**WRITTEN STATEMENT OF CONDITIONS**

The City of North Richland Hills received this plat on April 16, 2026. The Development Review Committee reviewed this plat on April 21, 2026. The following represents the written statement of the conditions for **CONDITIONAL APPROVAL** of the plat.

**PRELIMINARY PLAT**  
**SMITHFIELD TERRACE**  
LOTS 1-17, BLOCK 1  
&  
LOTS 1-18, BLOCK 2  
4-OPEN SPACE LOTS- 1X & 2X, BLOCK 1  
1X & 2X, BLOCK 2

PLAT26-0107  
CASE: PLAT26-0160

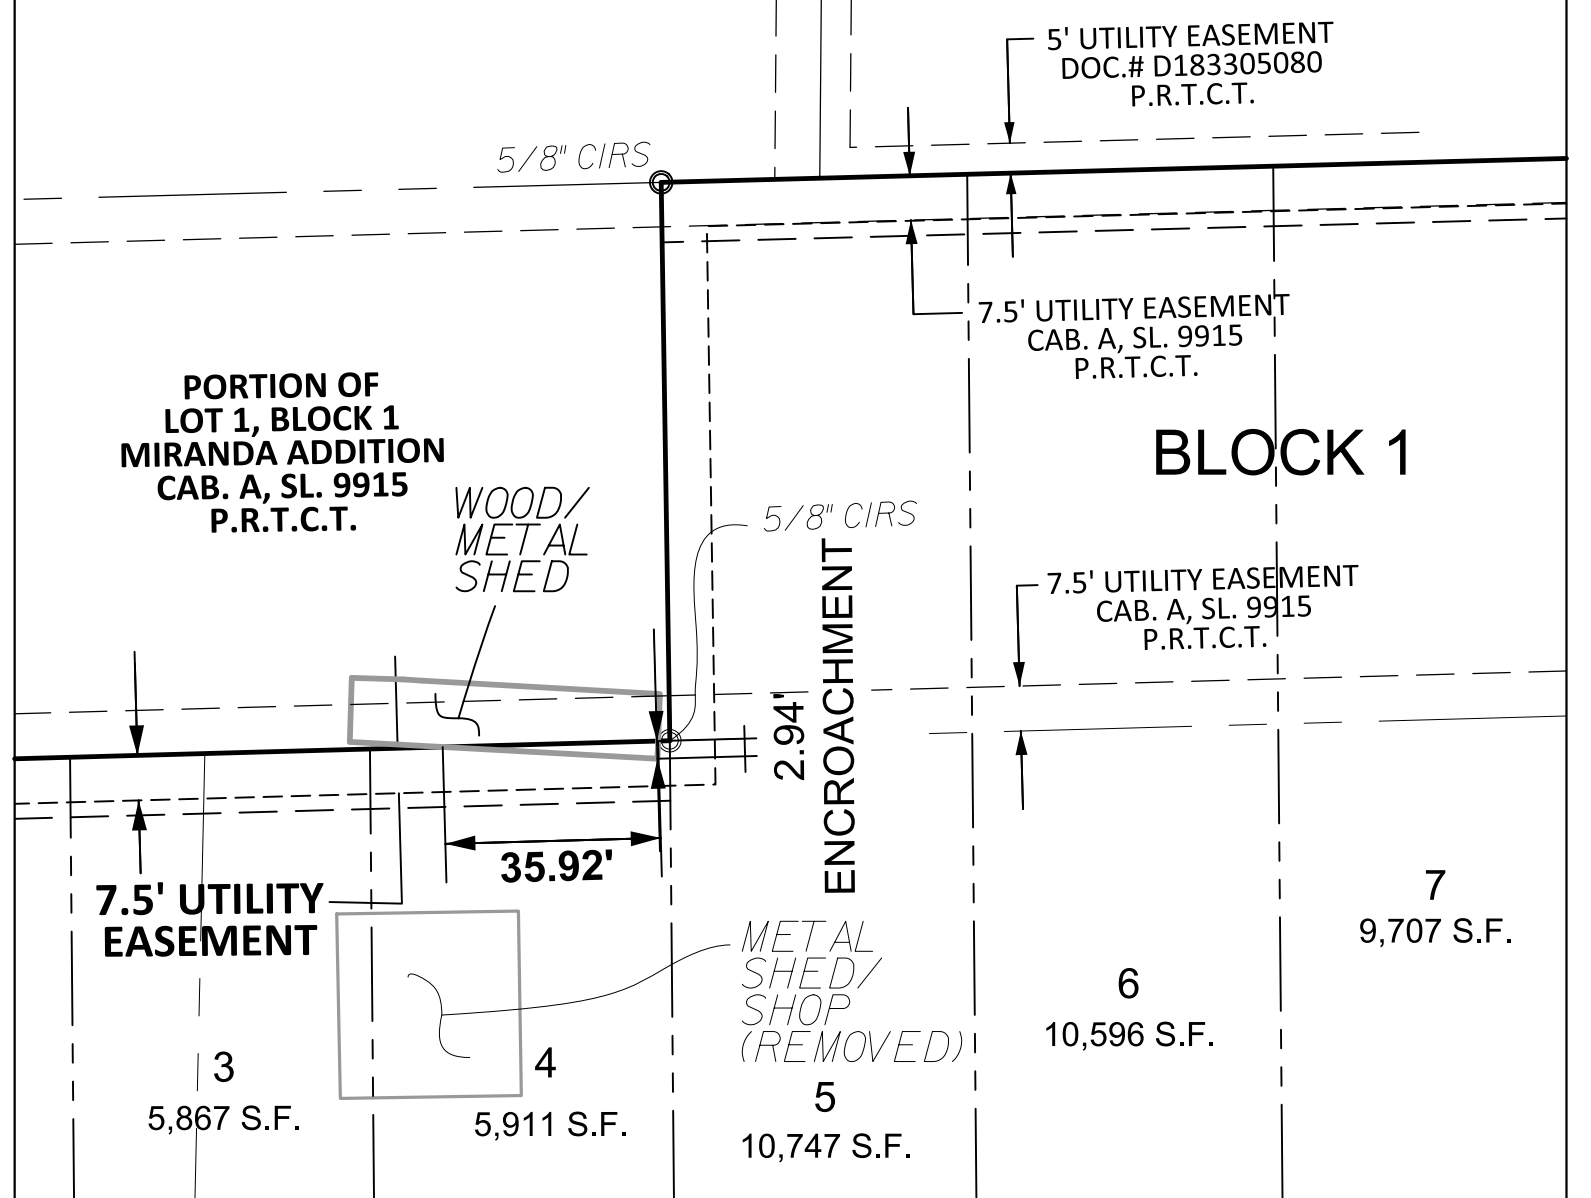
See DRC review letter regarding masonry screening wall requirements adjacent to Hewitt Street

Is this being abandoned? Not shown in preliminary utility plan

Is this easement intended to remain or be vacated? The easement affects the building envelope on Lots 9 and 10

Is this easement intended to remain or be vacated? The easement makes Lot 3 unbuildable and affects the building envelope on Lots 8-10.

This drainage easement dissecting the lot will make it unusable since structures cannot be built in a drainage easement.

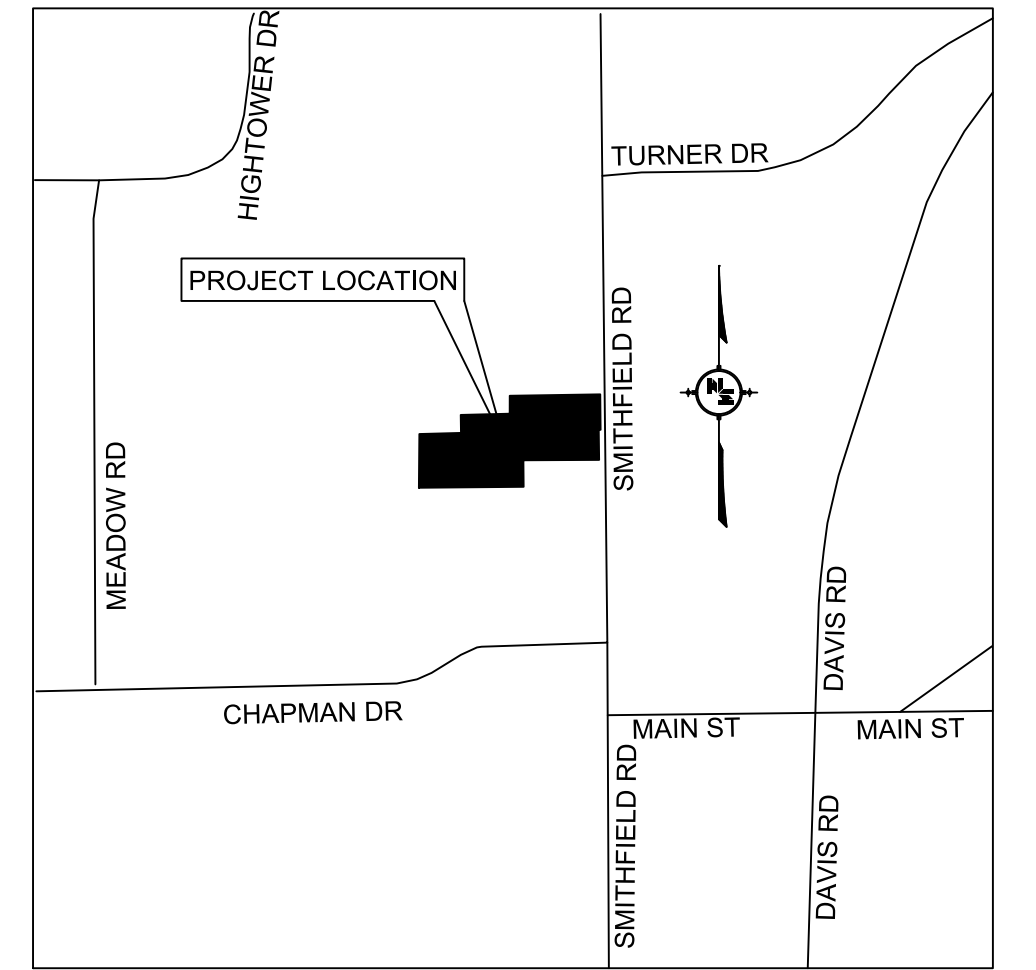
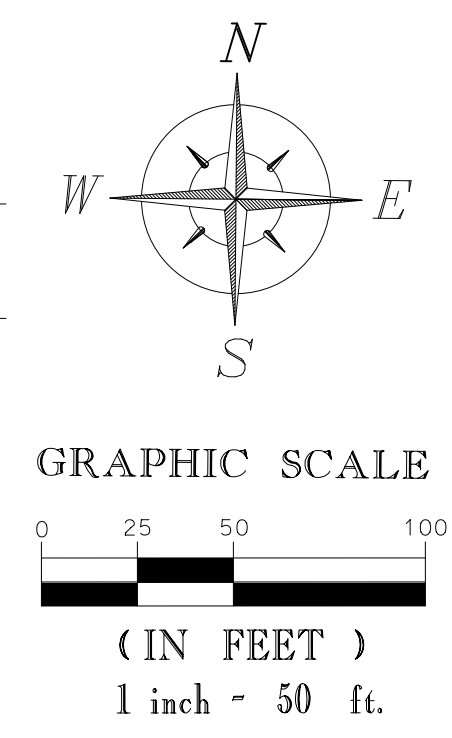
County recording block may be removed from the drawing as it is not necessary. The preliminary plat is not recorded, and the final plat would be recorded electronically.
